DEVELOPMENT ASSESSMENT REPORT	
<b>Application No.</b>	DA/2023/0322
<b>Address</b>	47 Darling Street BALMAIN EAST NSW 2041
<b>Proposal</b>	Alterations and additions of an existing 2 storey terrace including the addition of a third level with deck, reconfiguration of external windows and internal renovation of the existing house.
<b>Date of Lodgement</b>	15 May 2023
<b>Applicant</b>	Emily Sunman
<b>Owner</b>	Ms Emily J Peters
<b>Number of Submissions</b>	6
<b>Value of works</b>	\$1,295,250.00
<b>Reason for determination at Planning Panel</b>	Section 4.6 variation exceeds 10% (FSR/landscaping)
<b>Main Issues</b>	Heritage impacts, FSR breach
<b>Recommendation</b>	Approved with Conditions
<b>Attachment A</b>	Recommended conditions of consent
<b>Attachment B</b>	Plans of proposed development
<b>Attachment C</b>	Section 4.6 Exception to Development Standards
<b>Attachment D</b>	Heritage Impact Statement

This report is an assessment of the application submitted to Council for alterations and additions to an existing two storey terrace including the addition of a third level with deck, reconfiguration of external windows and internal renovation of the existing house at 47 Darling Street, B

Figure 3: Rear Elevation of 47 Darling Street, as per D/2009/300  
(subject to deletion of deck)

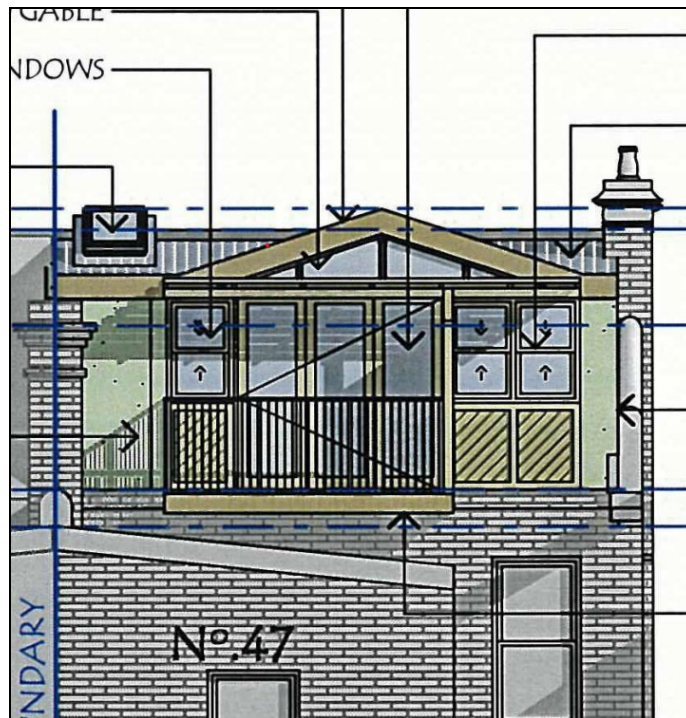
It is noted that the approved Development Application on the subject site (D/2009/300) was for a similar attic addition, with a deck. This application was approved subject to design change conditions, namely Condition 2(d) which required deletion of the deck off the attic (see Figure 3 on the following page).

Figure 4: Sightlines from proposed terrace to No. 49 Darling Street

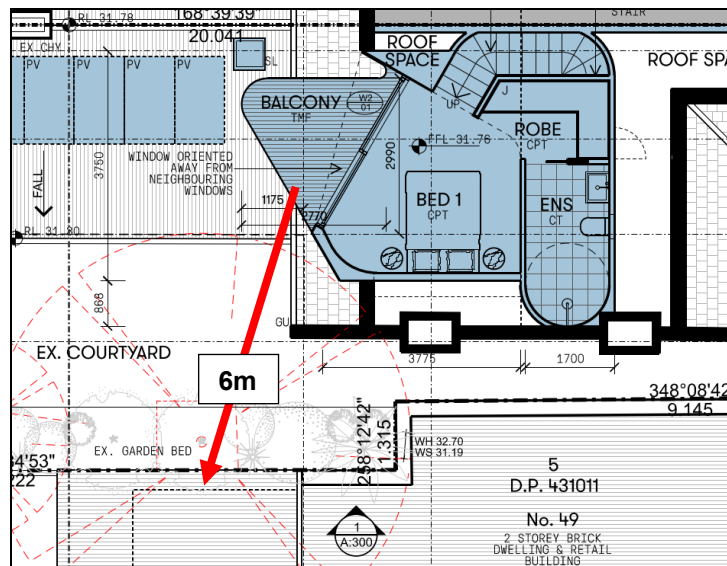
Section C3.11 of the LDCP contains provisions relating to visual privacy. Given the location and scale of the proposed terrace off bedroom 1, Control C4 applies to the proposal and indicates roof terraces will be considered where they do not result in adverse privacy

impacts to surrounding properties. As previously indicated, the proposed terrace will result in sightlines across the western side boundary to the neighbouring dwelling at No. 49 Darling Street. This includes sightlines to the living room/kitchen of that property, within 6m (see Figure 4).

As the proposed roof terrace will result in adverse privacy impacts to No. 49 Darling Street, the proposed design is not an acceptable amenity outcome. Furthermore, it is noted that the terrace does not comply with the maximum depth and width requirements of Control C9. Were a privacy screen to be erected at the western elevation, this would result in iconic view loss and is therefore not acceptable to ameliorate the privacy impact.

Figure 5: Proposed roof terrace with recommended condition of consent reduction in red

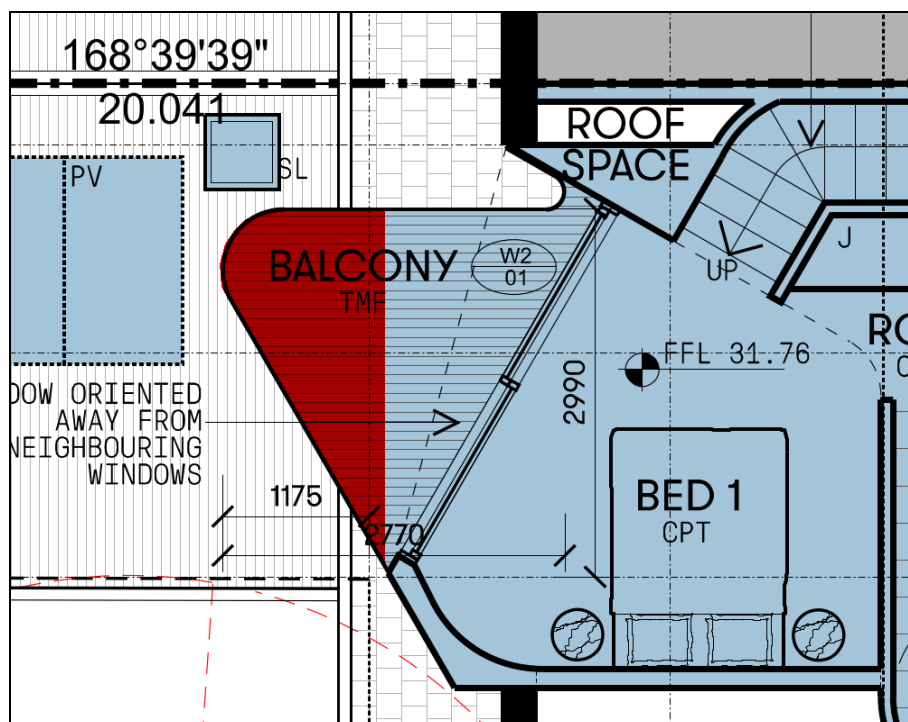
A design change condition is recommended to reduce the depth of the balcony, limiting potential sightlines to the living areas of No. 49 Darling Street (see Figure 5). This would still allow a modest balcony off bedroom 1.
